Intersection ID: 44690	Main Street: SMOOTH_PATH_DR	Cross Street: HARWOOD_HILLS_LN	Location:	NW
ADA ID: 6CD89A77D369	Ramp Type: PerpDiag	Initial Pass/Fail: Fail	Overall Compliance: No	Severity Score: 10

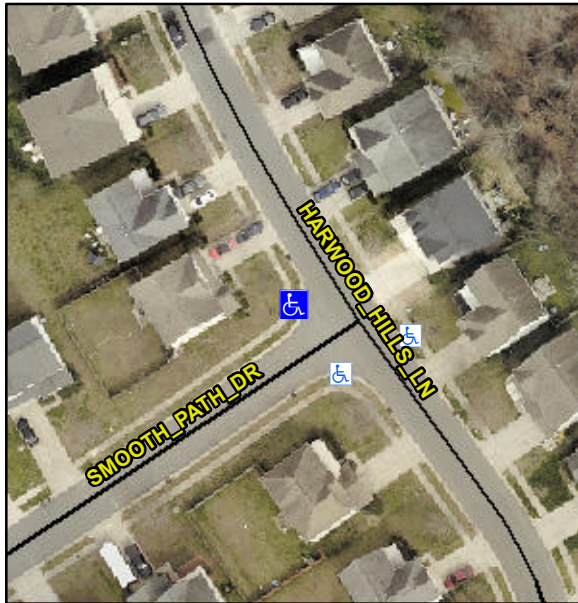
Not Found, R304.5.1, R304.5.3

Compliance	Description	Data	Compliance	Description	Data
N/A	Ramp Length (in)	50.0	Yes	Ramp Slope (%)	5.8
No	Ramp Width (in)	46.5	No	Ramp XSlope (%)	3.9
N/A	Flare Type LT	N/A	N/A	Flare Type RT	N/A
N/A	Flare Slope LT (%)	N/A	N/A	Flare Slope RT (%)	N/A
N/A	Flare Traversable LT?	N/A	N/A	Flare Traversable RT?	N/A
N/A	Landing Length (in)	N/A	N/A	DWS Provided?	N/A
N/A	Landing Width (in)	N/A	N/A	DWS Contrast?	N/A
N/A	Landing Slope (%)	N/A	N/A	DWS Length (in)	N/A
N/A	Landing X Slope (%)	N/A	N/A	DWS Full Width?	N/A
N/A	Landing Curb? (Y/N)	N/A	N/A	DWS Offset (in)	N/A
N/A	Shared Landing?	N/A			
N/A	Gutter Ponding?	N/A	N/A	Gutter Slope (%)	N/A
N/A	Gutter Lip Ht (in)	N/A	N/A	Gutter X Slope (%)	N/A
N/A	Painted X Walk1?	No	N/A	Painted X Walk2?	No
	X Walk 1 Direction	To S		X Walk 2 Direction	To E
N/A	X Walk 1 Width (in)	N/A	N/A	X Walk 2 Width (in)	N/A
	X Walk 1 Slope (%)	3.3		X Walk 2 Slope (%)	4.6
	X Walk 1 X Slope (%)	2.1		X Walk 2 X Slope (%)	4.5

Remove & Replace Curb Ramp With Two New Directional Ramps or Equivalent.
